UNITED STATES PATENT AND TRADEMARK OFFICE

Office Action Summary	Application No. 10/672,922	Applicant(s) CABLE ET AL.	
	Examiner Vinh T. Luong	Art Unit 3682

4. The drawings were received on November 8, 2007. These drawings are unacceptable by the Examiner because of the reasons, *inter alia*, listed below:

ATTACHMENT

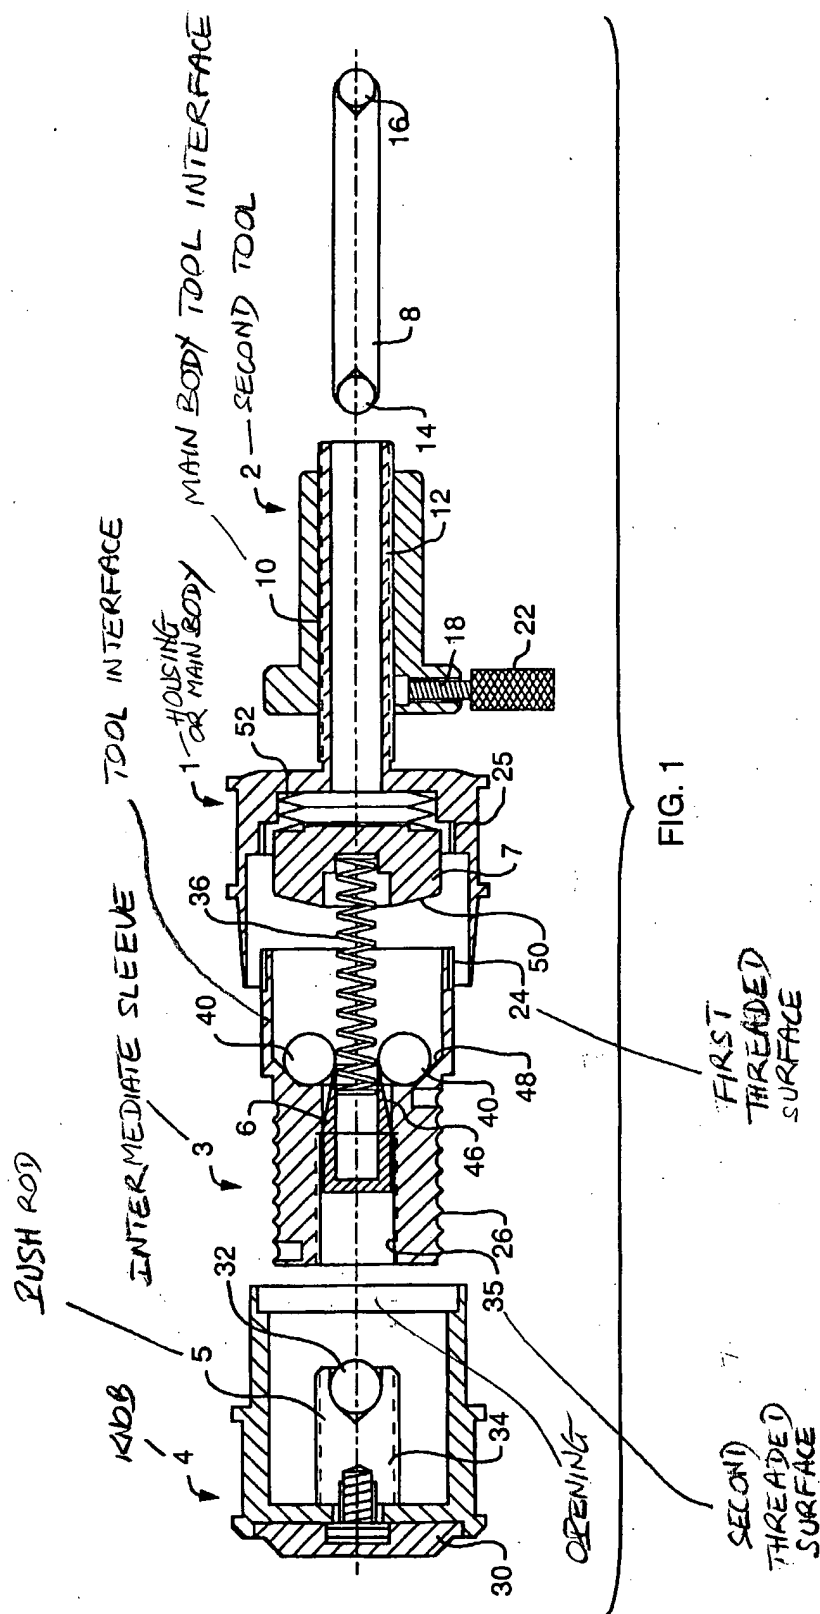
Regarding Claim 1, Cable teaches a differential adjuster, comprising: an intermediate actuator sleeve 3 with a first threaded surface 24 *operatively* engaging a housing 1 to adjust the position of the intermediate actuator sleeve 3, a second threaded surface 35 *operatively* engaging a push rod 5 to adjust the position of the intermediate actuator sleeve 3 relative to the push rod 5, and a tool interface (at 48 in FIG. 1, see Attachment hereinafter "Att.").

Regarding Claim 17, see a knob 4 *operatively* coupled to the main body 1 to provide a coarse adjustment, the knob 4 defining an opening (Att.) allowing access to the tool interface.

Regarding Claim 41, the intermediate actuator sleeve 3 includes a tool interface (at 48 in FIG. 1, see Att.).

Regarding Claim 42, the tool interface (Att.) of the intermediate actuator sleeve 3 is capable of accommodating an adjustment tool, the adjustment tool chosen from the group consisting of a spanner wrench, a socket, a screw driver, a ball driver, and an Allen wrench. Moreover, note that referring the differential adjuster to the merely inferentially included element or intended use element, such as, the tool that engages the tool interface of the intermediate actuator sleeve is not accorded patentable weight.

FIG. 2

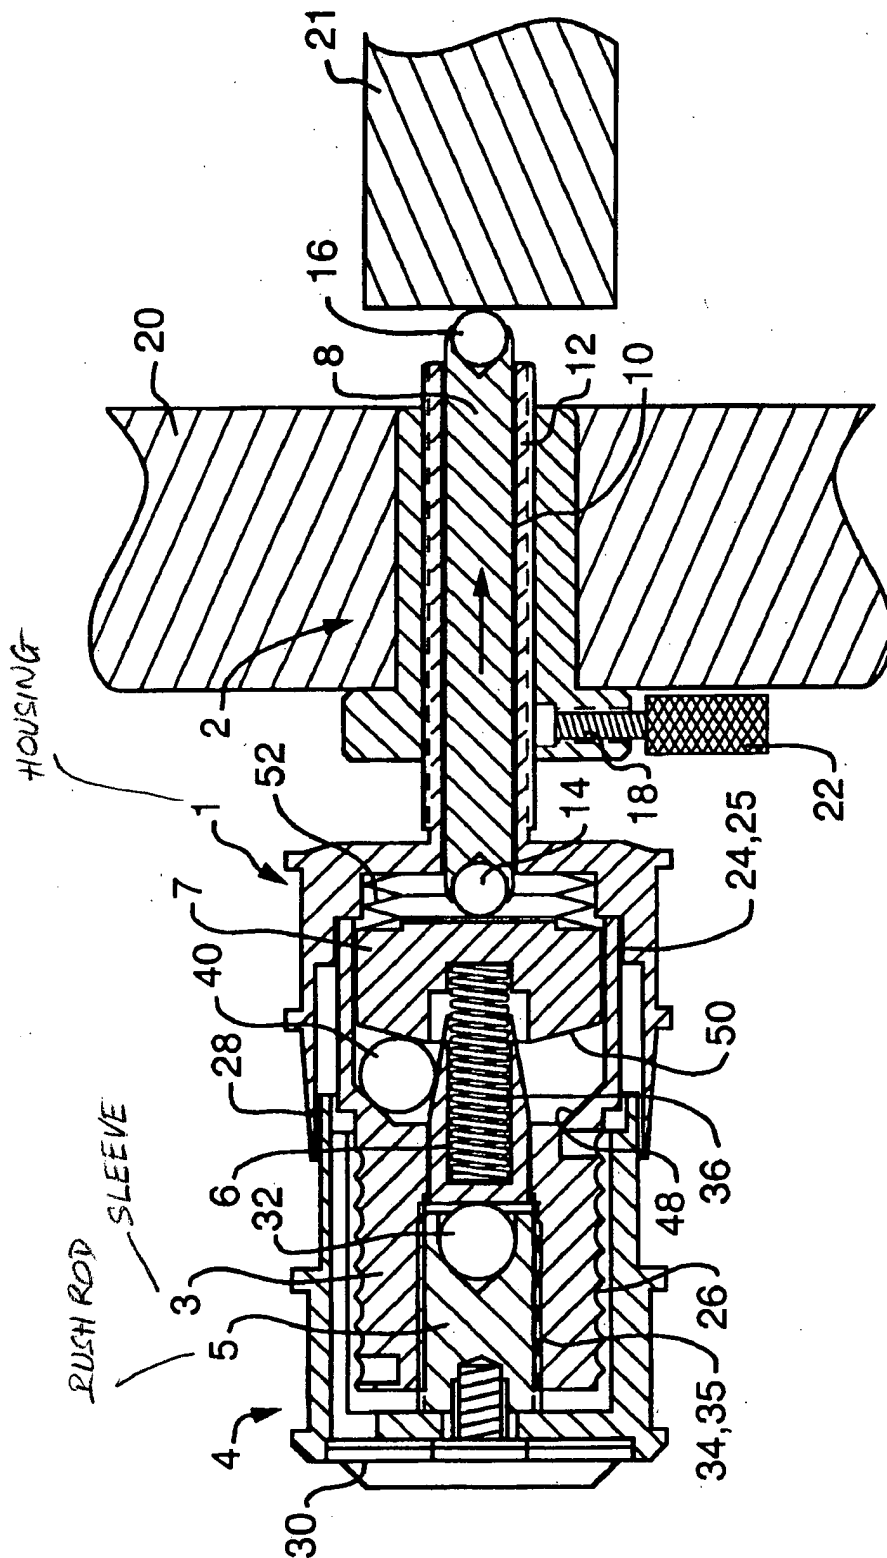
Regarding Claim 7, Cable's first threaded surface 24 is equivalent to the internal threaded surface 25 (FIG. 2) and Cable's second threaded surface 35 is equivalent to the external threaded surface 26. See MPEP 2144.06 *supra*.

Regarding Claim 25, the housing 1 is a component mount or positioner that engages the first threaded surface 24 of the intermediate actuator sleeve 3 (FIGS. 2 and 3).

The Applicant respectfully submits that common knowledge based on standard physics text books teaches that the relative rotation between Cable's push rod 5 and body 1 is inherently restricted by the frictional force resulting from the motions of the ball detent 40, spring 6, and tapered pin 6, *etc.* as seen in FIG. 2.
